INDIAN POINT NUCLEAR GENERATING UNIT NO. 3

AMENDMENT TO FACILITY OPERATING LICENSE

Amendment No. 75
License No. DPR-64

SAFETY EVALUATION BY THE OFFICE OF NUCLEAR REACTOR REGULATION
RELATED TO AMENDMENT NO. 75 TO FACILITY OPERATING LICENSE NO. DPR-64
POWER AUTHORITY OF THE STATE OF NEW YORK
INDIAN POINT NUCLEAR GENERATING UNIT NO. 3
DOCKET NO. 50-286

Figure 3.10-4
Four Loop Operation

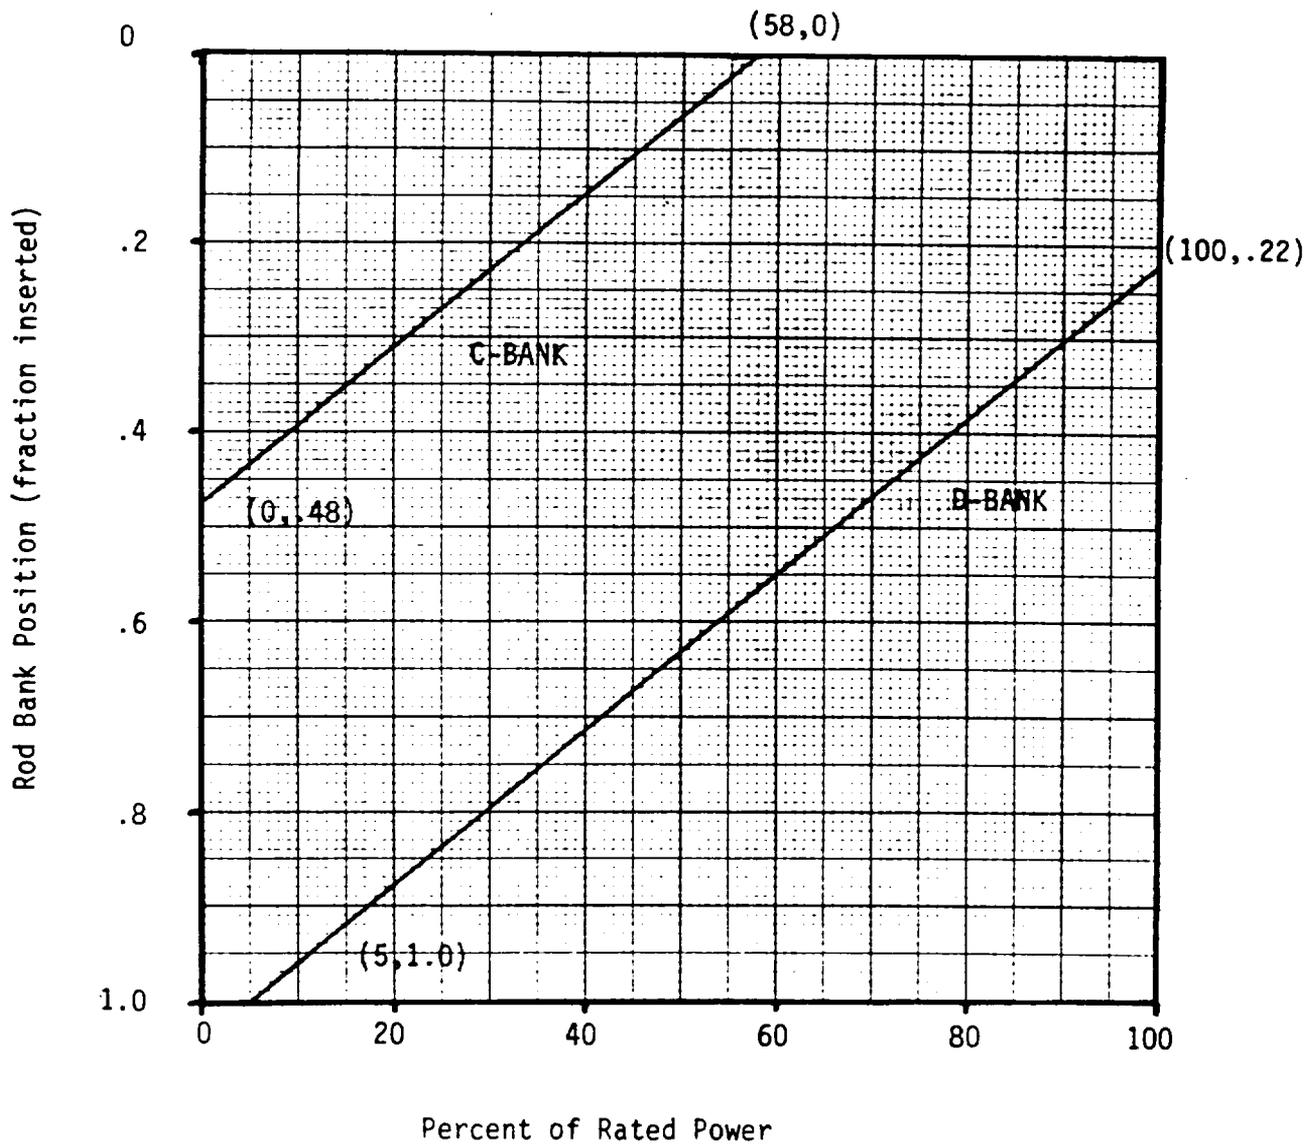
The amendment revises the Technical Specification requirement for control bank insertion limits. The revision is being made to reflect a more conservative insertion position for the C and D control banks.

By letter dated March 10, 1987, the Power Authority of the State of New York requested a revision to the Technical Specifications for Indian Point Nuclear Generating Unit No. 3. The amendment would revise Figure 3.10-4 which provides the control bank insertion limit curves.

The proposed Technical Specifications provide revised C and D control bank insertion limits. The proposed insertion limits are more restrictive than the current specification as they will limit the insertion of control banks C and D more than the present specification. This change will result in increased flexibility in core design at the expense of operational flexibility. The reduction in control bank insertion limits will result in a reduction in the calculated core peaking factor (Fq). We have reviewed the amendment application and find the proposed change acceptable.
